Burlington Planning Commission Special Meeting

RE: PLANNING COMMISSION TRANSMITTAL OF ZA-16-14 DOWNTOWN MIXED USE CORE OVERLAY

As revised by the Planning staff ~~–June 15, to reflect Planning Commission comments & concerns–~~ July 1 2016.

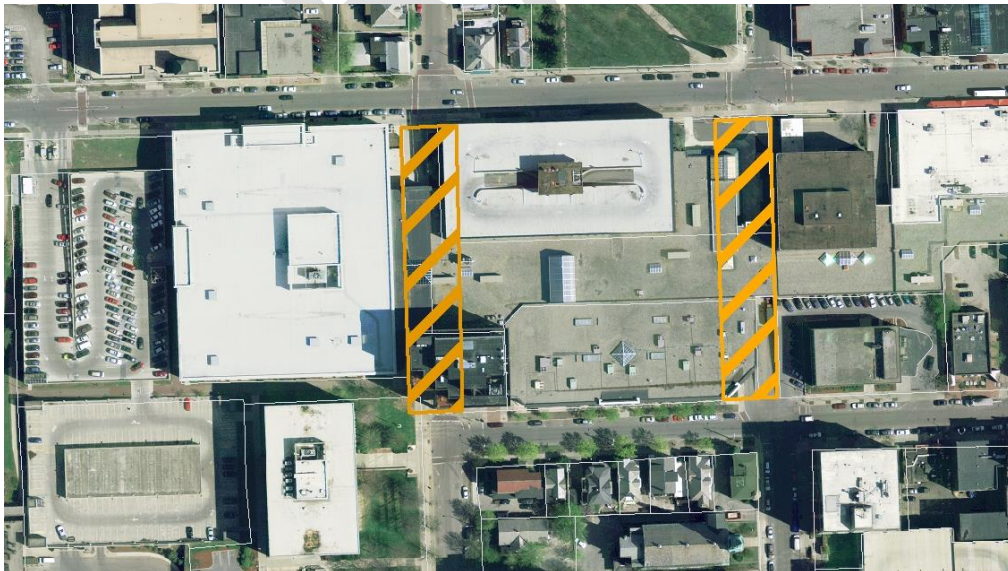
Comment [DEW1]: This will ensure that the proposed north-south connectivity on Pine and St. Paul streets envisioned in planBTV is accomplished. The City will have 120-days to initiate proceedings to acquire any land within this area that may be proposed for new development.

Figure 4.4.1-2 Measuring Height Limits for Church Street Buildings

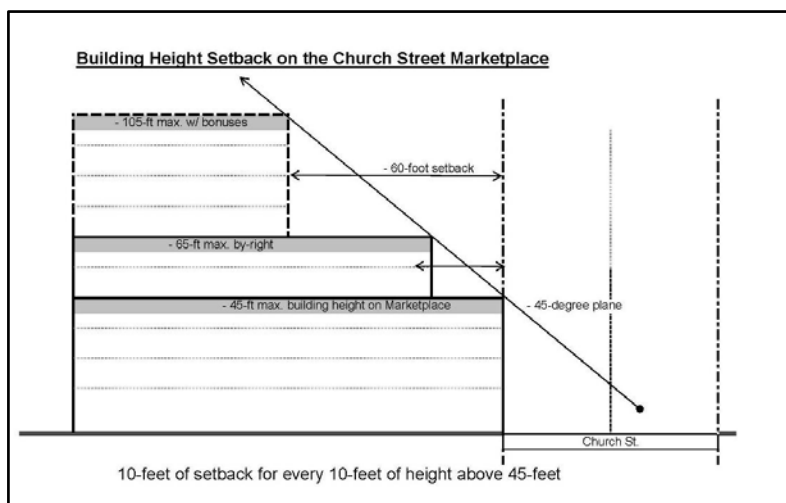
Comment [DEW3]: While outside of the proposed new overlay, this change is already envisioned as part of the currently proposed form-based code to provide better compatibility of building heights on Church Street.

For the purposes protecting the historic character and scale of buildings along the Church Street Marketplace, the maximum height of any building fronting on Church Street shall be limited to 4-stories not to exceed 45-feet. Any portion of a building exceeding 45-feet shall be set-back a minimum of 10-feet for every 10-feet of additional building height above 45-feet.
